SUBJECT: SUSQUEHANNA STEAM ELECTRIC STATION, UNITS 1 AND 2 - STAFF ASSESSMENT OF INFORMATION PROVIDED PURSUANT TO TITLE 10 OF THE *CODE OF FEDERAL REGULATIONS* PART 50, SECTION 50.54(f), SEISMIC HAZARD REEVALUATIONS FOR RECOMMENDATION 2.1 OF THE NEAR-TERM TASK FORCE REVIEW OF INSIGHTS FROM THE FUKUSHIMA DAI-ICHI ACCIDENT (CAC NOS. MF3707 AND MF3708)

STAFF ASSESSMENT BY THE OFFICE OF NUCLEAR REACTOR REGULATION
RELATED TO SEISMIC HAZARD AND SCREENING REPORT
SUSQUEHANNA STEAM ELECTRIC STATION, UNITS 1 AND 2
DOCKET NOS. 50-387 AND 50-388

Figure 3.3-1 Plot of Staff's and Licensee's Base Case Shear-Wave Velocity Profiles for the SSES Site

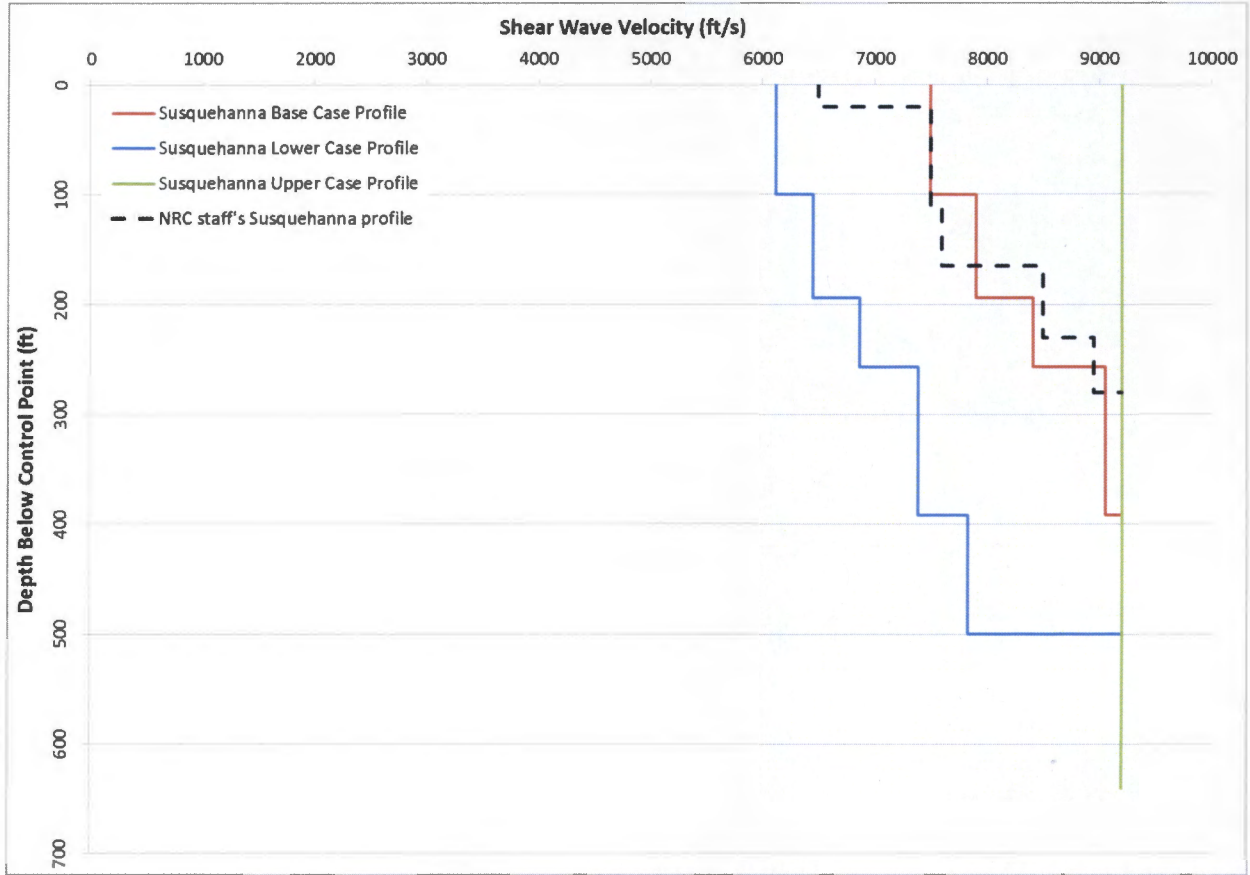
Because of the high quality of the data and the geologic consistency between the SSES and BBNPP sites, the staff's base case shear-wave velocity is based on measured shear-wave velocity data reported in the SSES UFSAR (PPL, 2011) and the BBNPP FSAR (Unistar, 2013). In addition, due to the consistencies between the SSES and BBNPP sites, the NRC staff used a single base case velocity profile rather than the three profiles developed by the licensee. Figure 3.3-1 of this assessment shows the NRC staff velocity profile compared to the base case profiles developed by the licensee.

Figure 3.3- 2 Plot Comparing the Staff's and the Licensee's Median Amplification Functions and Uncertainties for the SSES site.

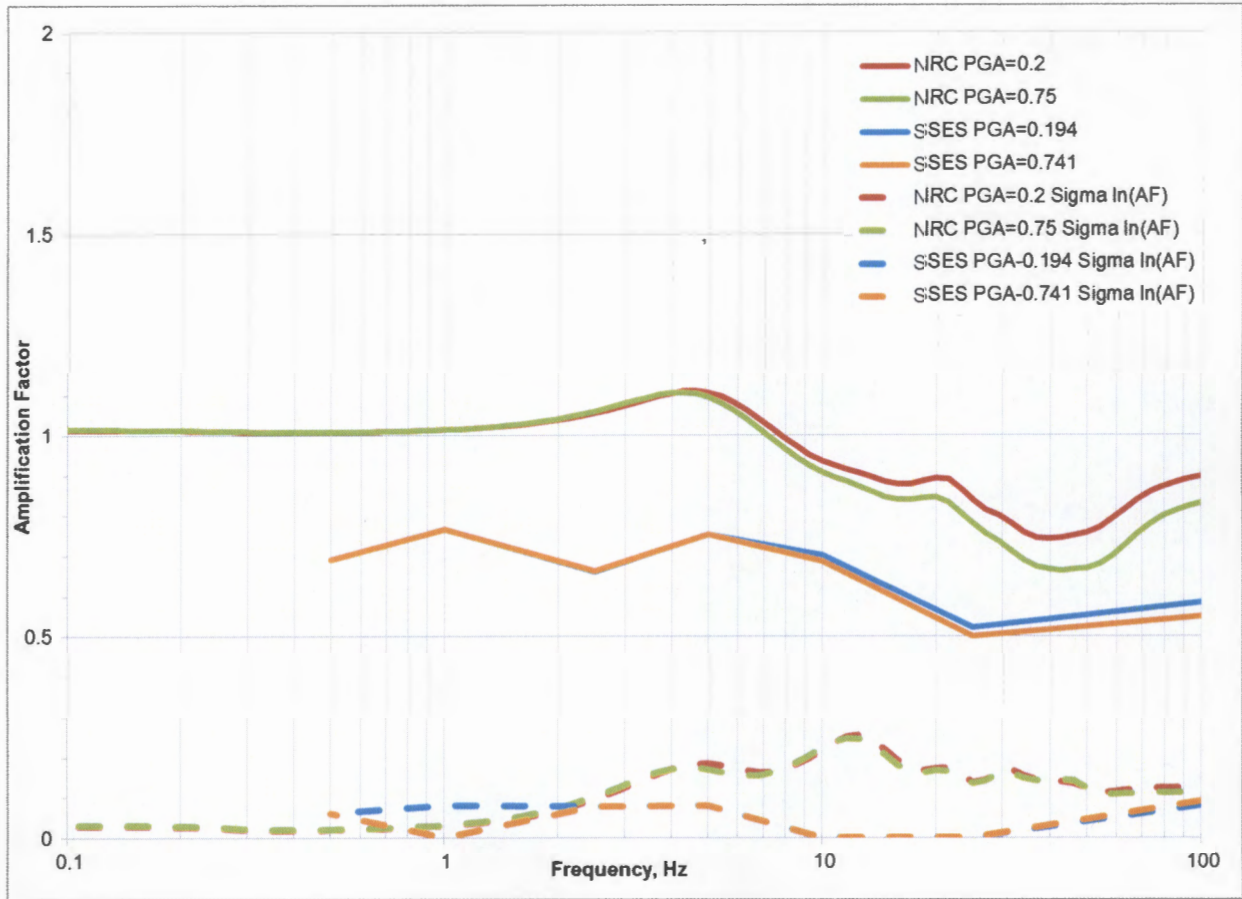
Figure 3.3-2 of this assessment shows a comparison of the staff's and licensee's median site amplification factors and uncertainties (± 1 standard deviation) for 2 of the 11 input loading levels. The staff's median site amplification factors are larger than the licensee's. Differences in site amplification curves developed by the NRC staff and the licensee are due to differences in site base case profiles and kappa values. However, these differences in the site amplification curves do not result in large difference in the control point hazard curves, or the GMRS, as described below.

Figure 3.3-3 Plot Comparing the Staff's and the Licensee's Mean Control Point Hazard Curves at a Variety of Frequencies for the SSES site

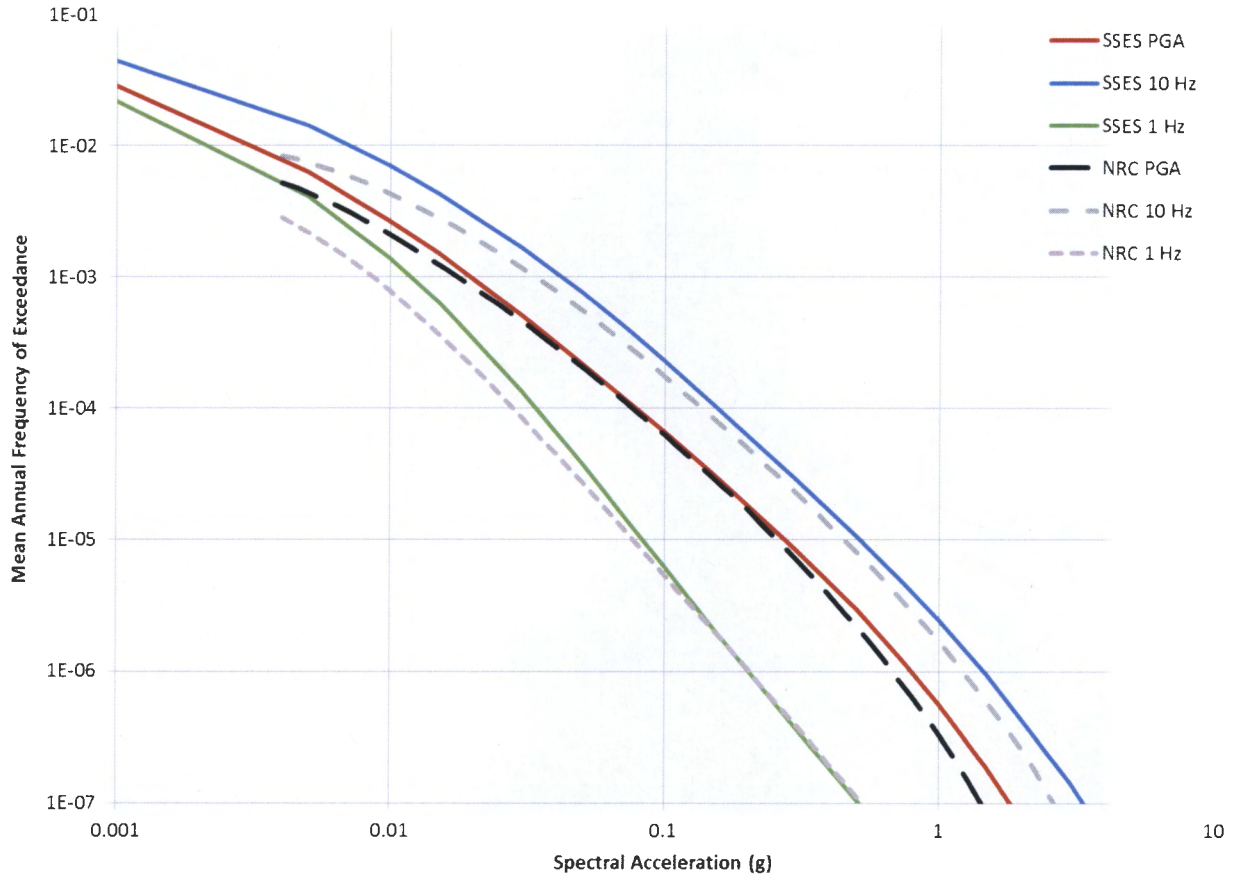
Figure 3.3-3 of this assessment shows a comparison of the licensee's and staff's control point hazard curves. The staff's median site amplification factors are similar to the licensee's and Figure 3.3-3 of this assessment figure shows that the differences in site amplification curves had only a minor impact on the control point seismic hazard curves. Appendix B of the SPID provides guidance for performing site response analyses, including capturing the uncertainty for sites with less subsurface data; however, the guidance is neither entirely prescriptive nor comprehensive. As such, various approaches in performing site response analyses, including the modeling of uncertainty, are acceptable for the 50.54(f) response. In summary, the NRC staff concludes that the licensee's site response was conducted using present-day guidance and methodology, including the NRC-endorsed SPID. The NRC staff performed independent calculations which confirmed that the licensee's amplification factors

and control point hazard curves adequately characterize the site response, including the uncertainty associated with the subsurface material properties, for the SSES site.

Figure 3.4-1 Comparison of the Staff's GMRS with Licensee's GMRS and the SSE for the SSES site

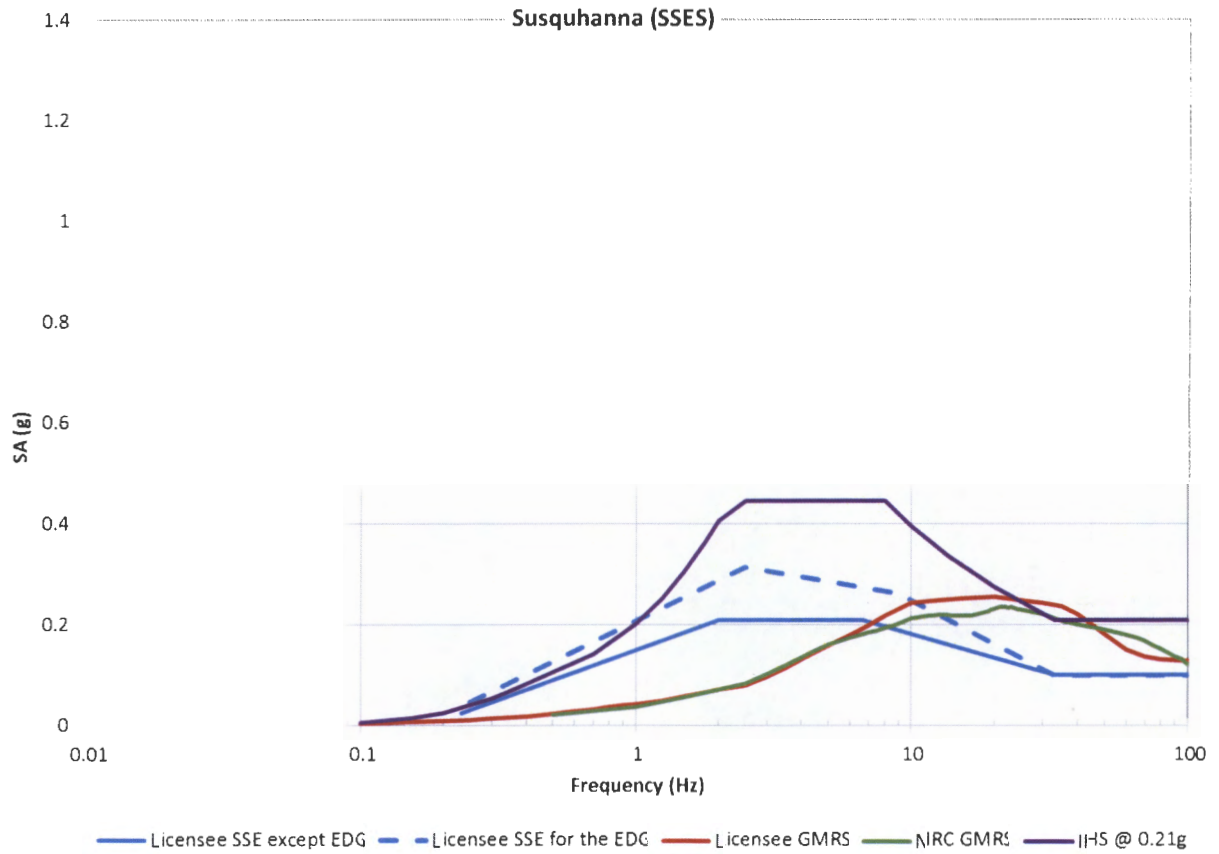
The NRC staff independently calculated the 10^{-4} and 10^{-5} UHRS using the results of its confirmatory PSHA and site response analysis, as described in Sections 3.2 and 3.3 of this NRC staff assessment, respectively. Figure 3.4-1 of this assessment shows a comparison of the GMRS determined by the licensee to that determined by the NRC staff. As shown in Figure 3.4-1, the licensee's GMRS shape is generally similar to that calculated by the NRC staff. The minor differences in the licensee's and staff's GMRS result from the differences in the site response analyses, as discussed in Section 3.3 above.

The NRC staff confirms that the licensee used the present-day guidance and methodology outlined in RG 1.208 and the SPID to calculate the horizontal GMRS, as requested in the 50.54(f) letter. The NRC staff performed both a PSHA and site response confirmatory analysis and achieved results consistent with the licensee's horizontal GMRS. As such, the NRC staff concludes that the GMRS determined by the licensee adequately characterizes the reevaluated hazard for the SSES site. Therefore, this GMRS is suitable for use in subsequent evaluations and confirmations, as needed, for the licensee's response to the 50.54(f) letter.
